FARRAGUT VISUAL RESOURCES REVIEW BOARD AGENDA

Farragut Town Hall
Board Room
Tuesday, December 12, 2023
7:00 p.m.

MEMORANDUM

TO: Farragut Visual Resources Review Board
FROM: Bart Hose, Assist. Community Development Director
SUBJECT: Regularly Scheduled Meeting - Tuesday, December 12, 2023, at 7:00 p.m.

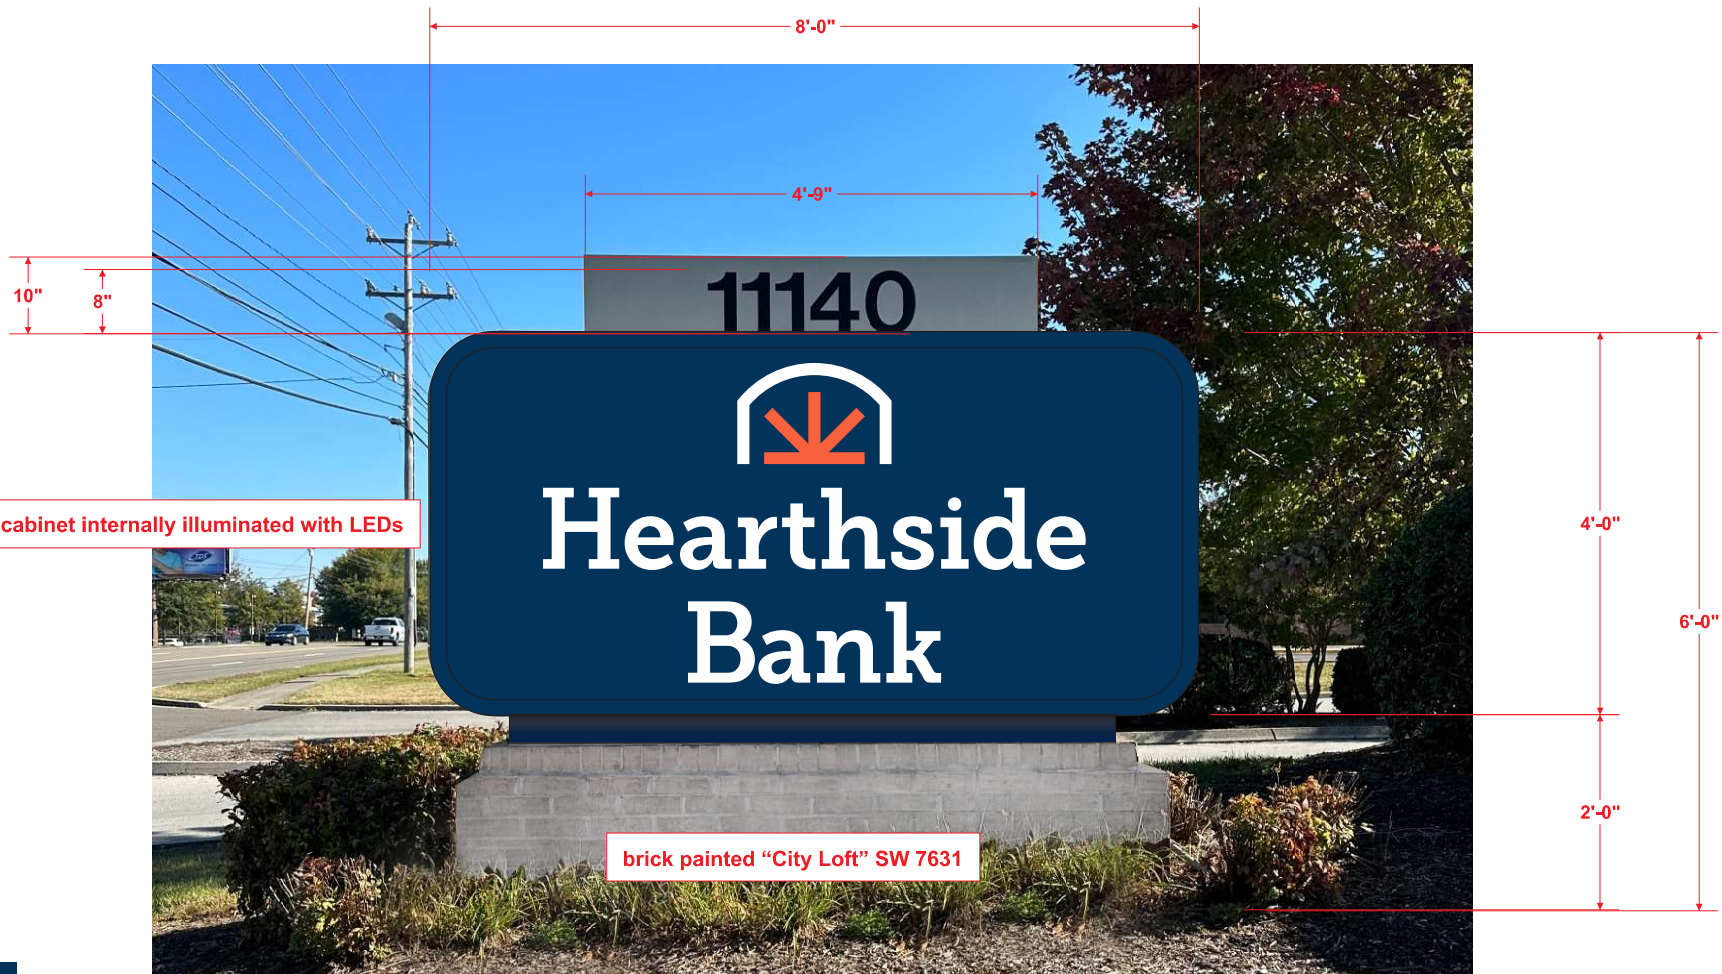
The application involves a new approximately 31 square foot monument sign for PALS Automotive Repair. The applicants will be remodeling the existing structure and have recently reviewed plan approval from the Planning Commission. Staff recommends approval of the sign subject to the following:

1. The sign site plan (including landscaping) will need to be revised to reflect the updated plan for the overall development site. The owners have made site layout changes based on input from the Planning Commission.

Landscape plan for the new Hearthside Bank located at 11140 Kingston Pike.

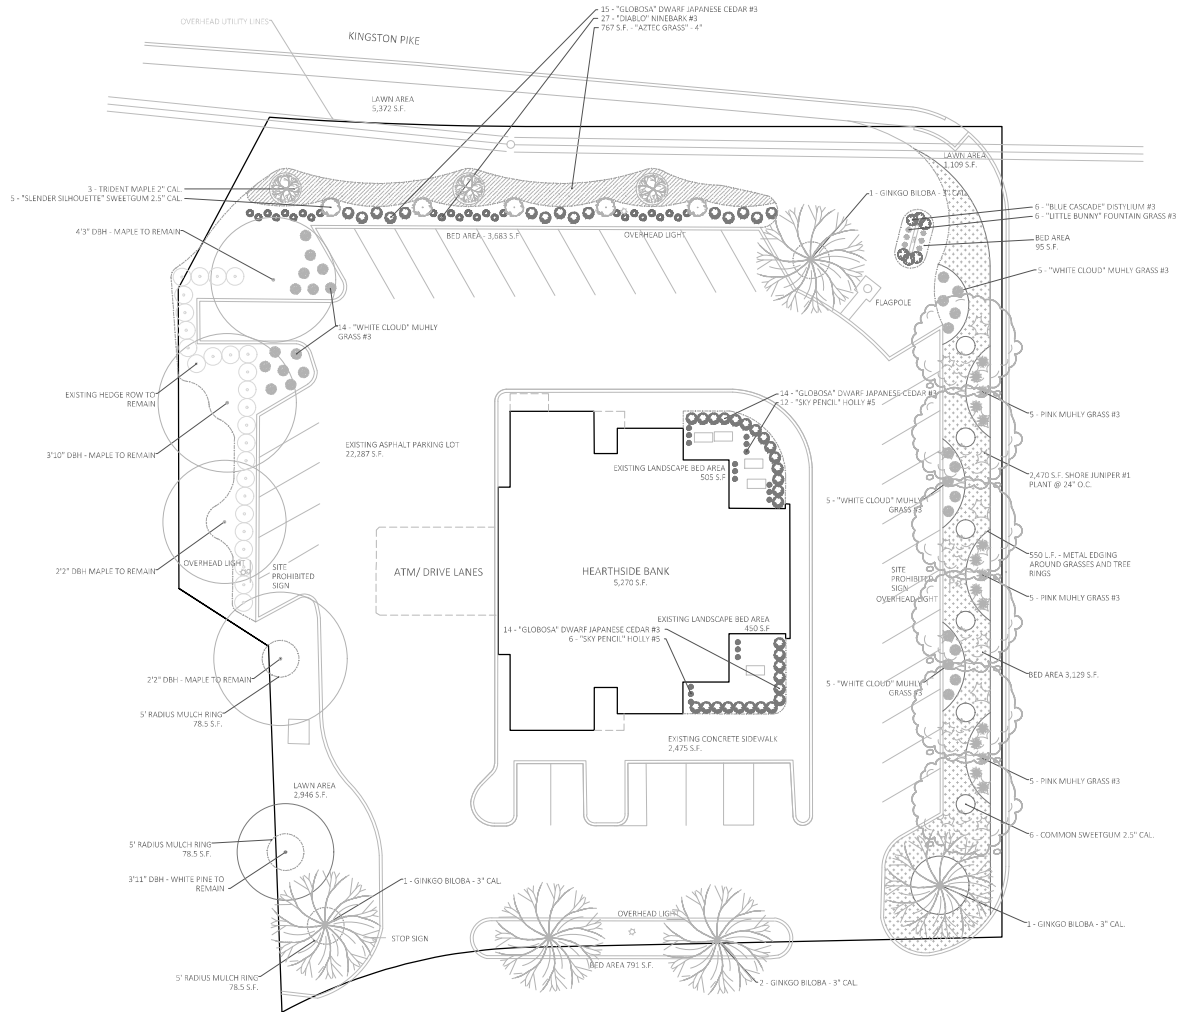
This request involves a largely new landscape plan for the new Hearthside Bank branch located at 11140 Kingston Pike. The bank is updating the site's existing landscaping in conjunction with their larger remodeling project. They are also replacing a number of existing trees that were found to be in poor condition due to damage and/or poor maintenance and pruning practices. The plan includes required shade trees, parking lot related landscaping, landscaping around the buildings, and the noted replacement trees. The staff recommends approval of the plan.

Landscape Plan - Overall Site

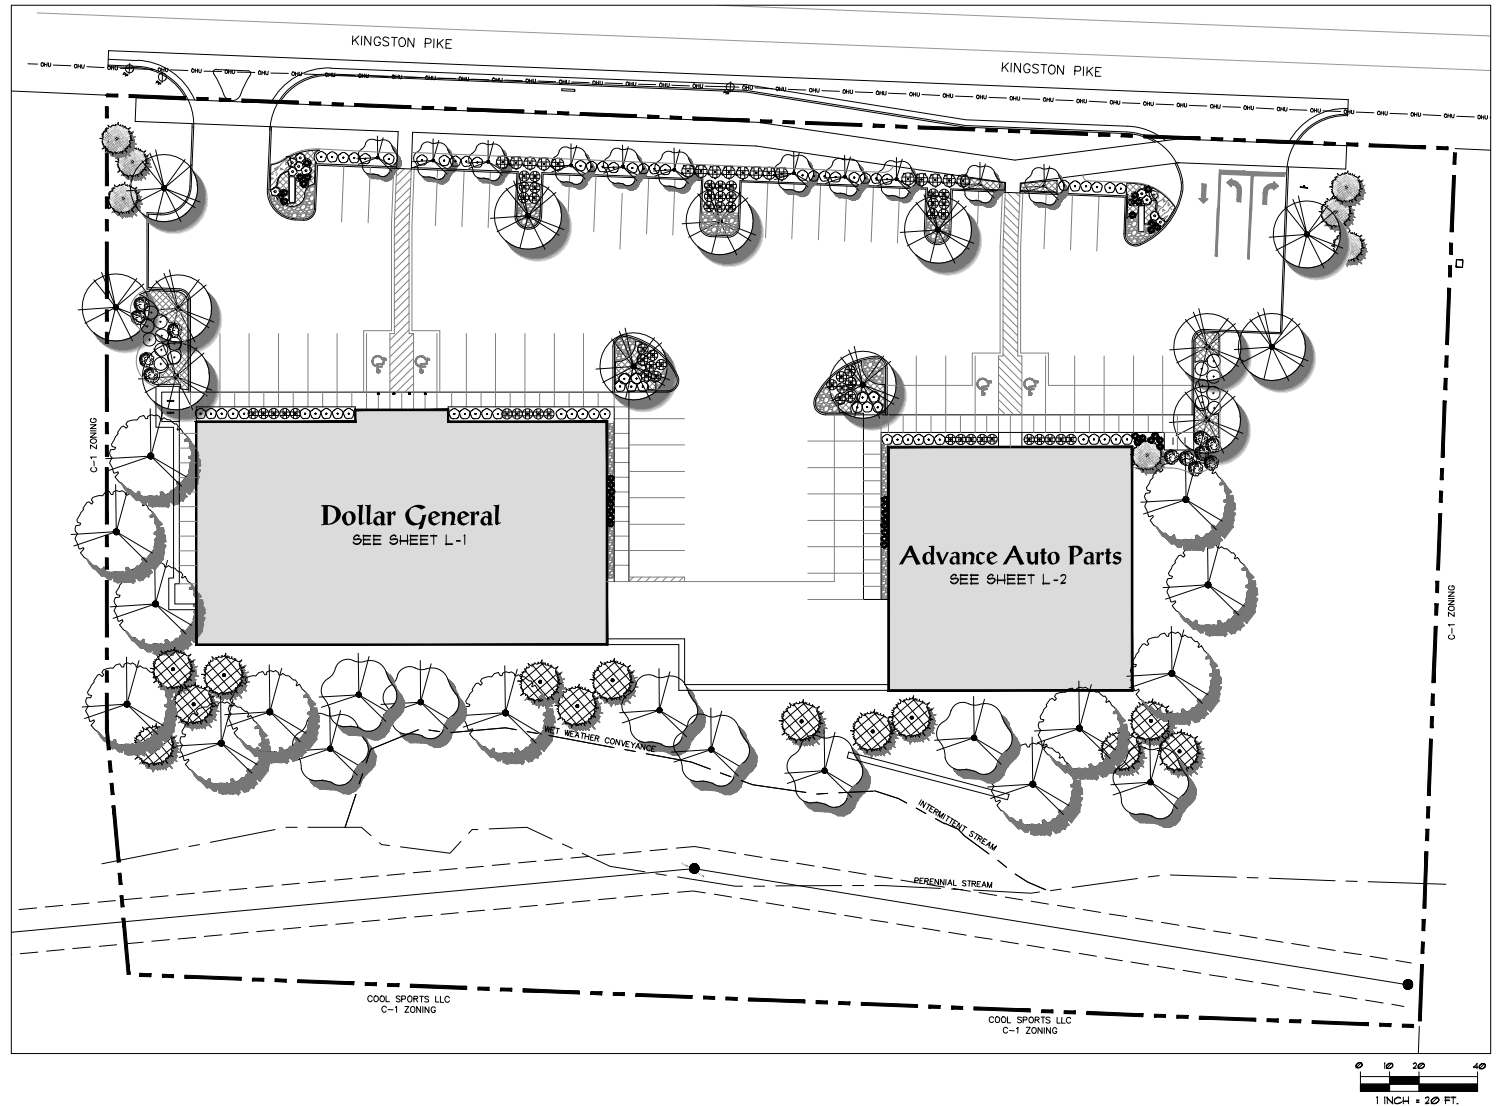
The plan includes required landscape elements for shade trees, parking lot screening, and landscaping around the buildings. The staff recommends approval.

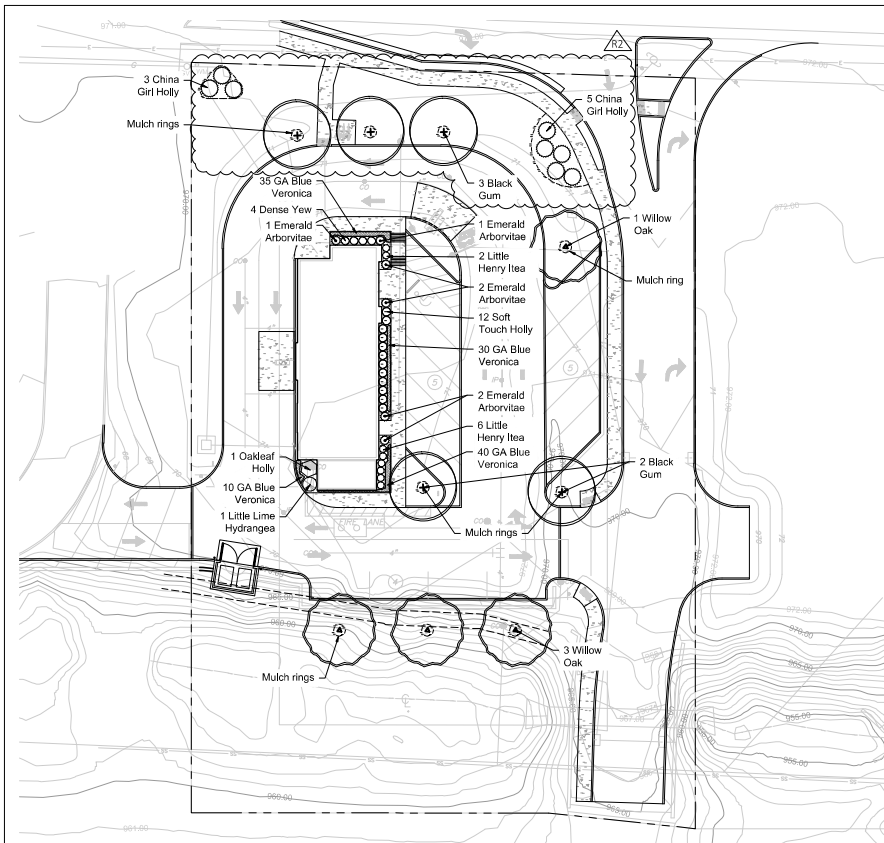
The plan includes required landscape elements for shade trees, parking lot screening, and landscaping around the buildings. The staff recommends approval subject to the following:

1. The addition of some additional plantings to better screen the drive-through lane and parking lot traffic lanes between the front of the building and Kingston Pike.
